Company	Trenz Electronic GmbH
PCN Number	PCN-20230524
Title	TE0813-01 to TE0813-02 Hardware Revision Change
Subject	Hardware Revision Change
Issue Date	2023-06-27

2.20 #20 Signal trace lengths changed

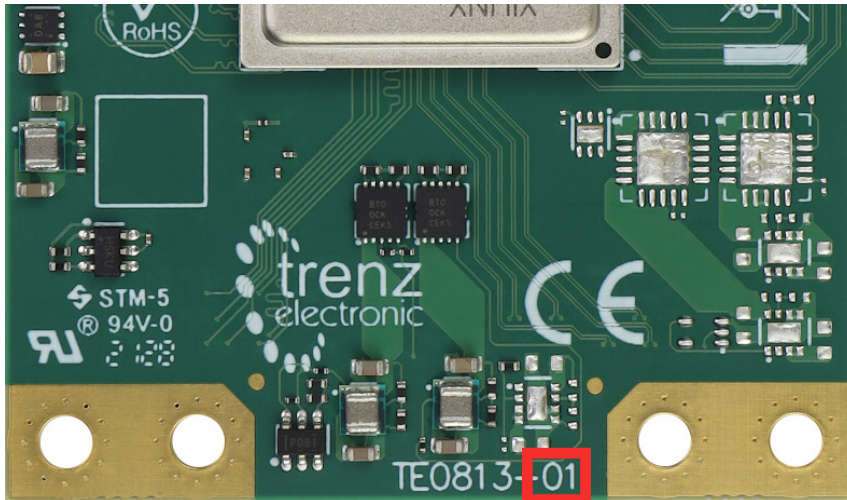
Type: PCB change

Reason: Result of changes above.

Impact: Changed trace length have to be taken into account in existing designs. The trace length for new revision will be available in [TE081x series pinout generator](#)¹. Please check if change in trace length still matches your requirements. Adaption of carrier may be necessary.
